ATTACHMENT 1

PROPOSED TECHNICAL SPECIFICATION CHANGE

NORTH ANNA UNIT NO. 1

ATTACHMENT 2

Figure 6.2.2 Facility Organization - North Anna - Units 1 & 2

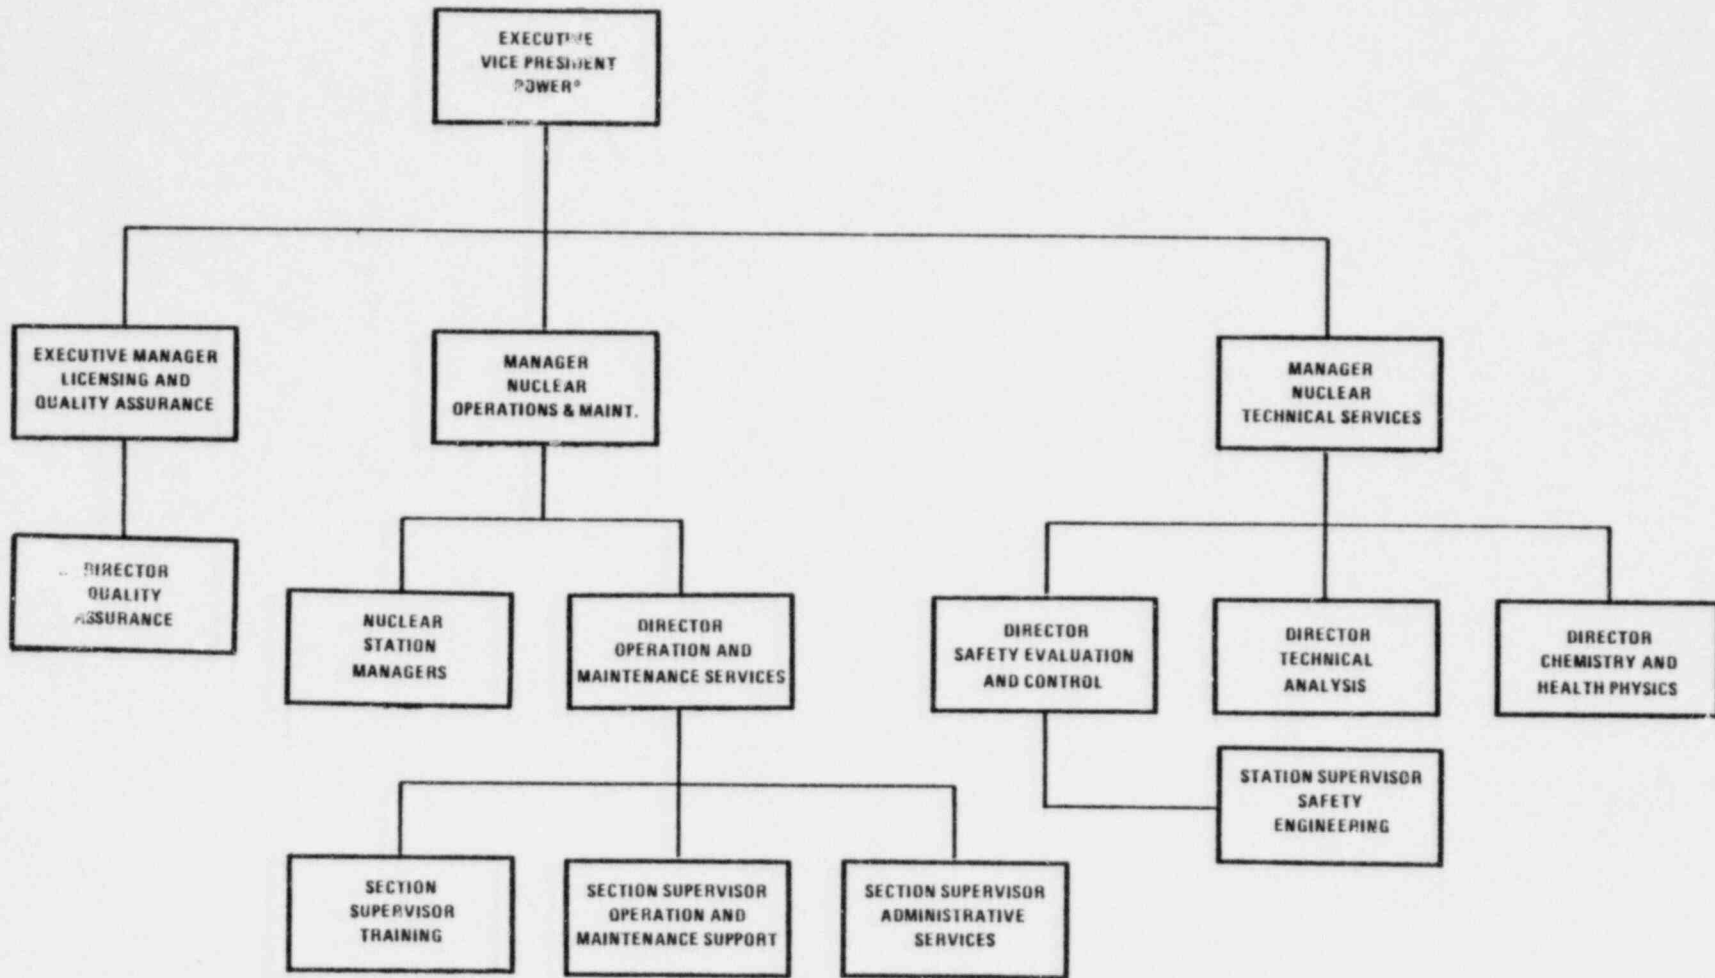
6.1.1 The Station Manager shall be responsible for overall facility operation, ~~and shall delegate in writing the succession to this responsibility during his absence.~~ SEE ATTACHED PAGE

In his absence, the Assistant Station Manager shall be responsible for overall facility operation. During the absence of both, the Station Manager shall delegate in writing the succession of this responsibility.

Figure 6.2.2 Facility Organization - North Anna - Units 1 & 2

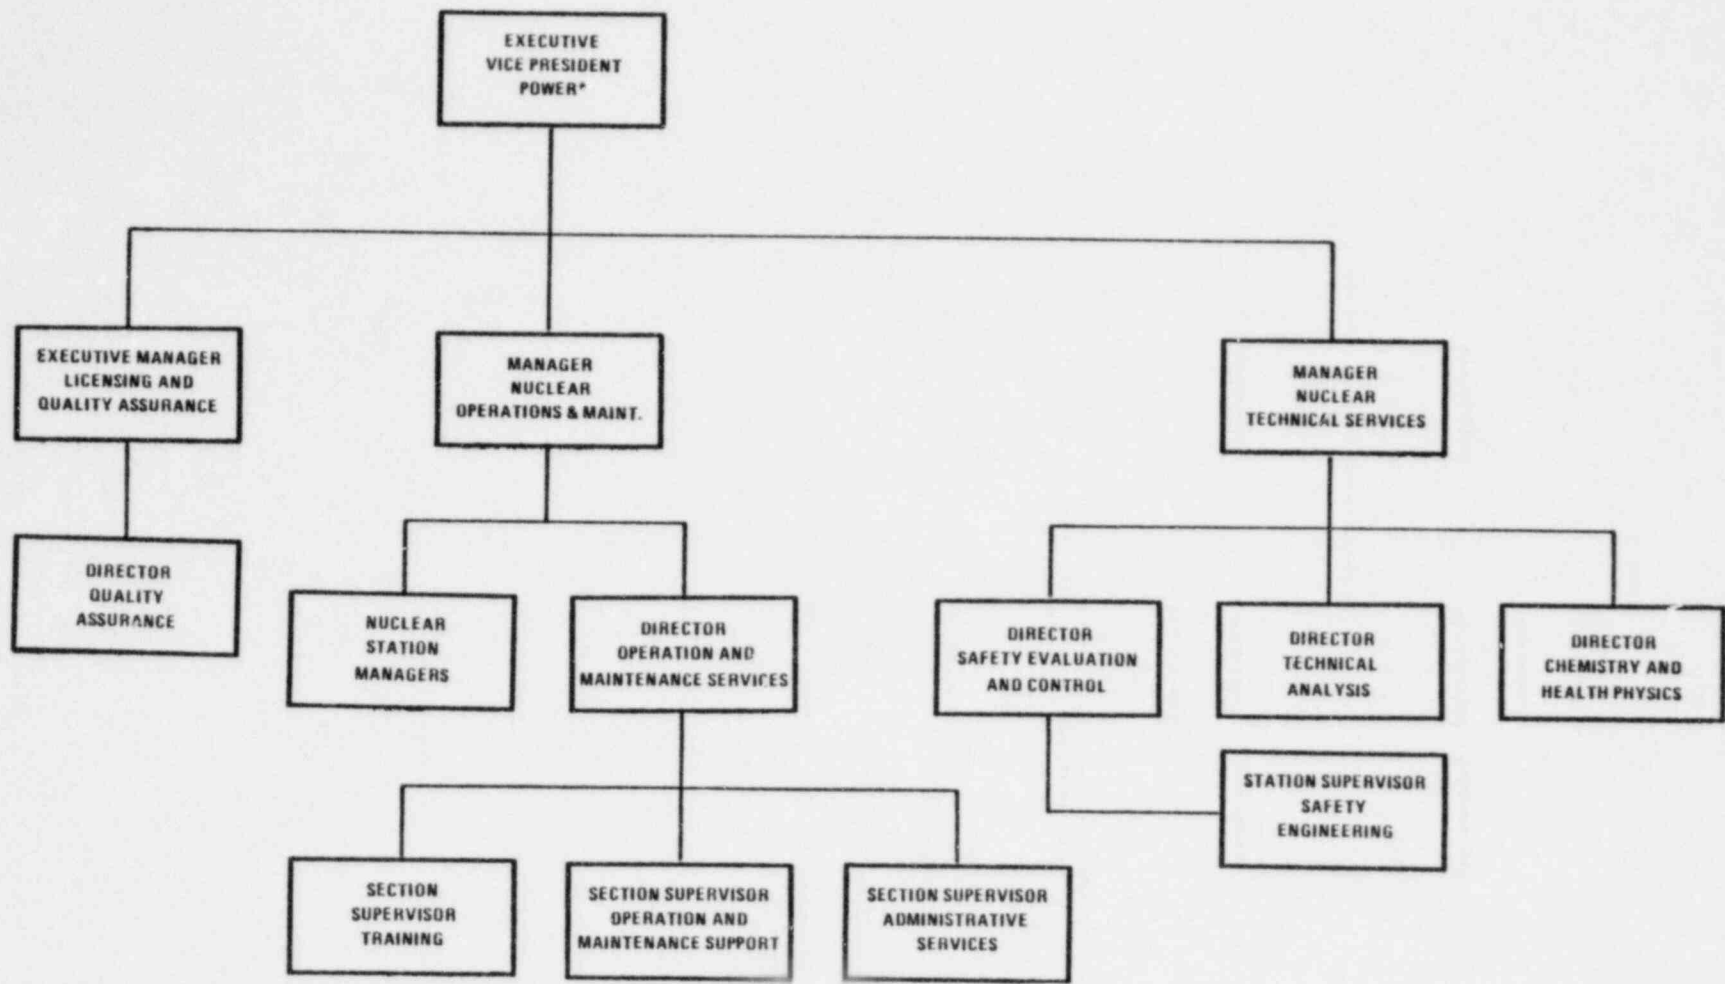
6.1.1 The Station Manager shall be responsible for overall facility operation, ~~and shall delegate in writing the succession to this responsibility during his absence.~~ SEE ATTACHED PAGE

In his absence, the Assistant Station Manager shall be responsible for overall facility operation. During the absence of both, the Station Manager shall delegate in writing the succession of this responsibility.
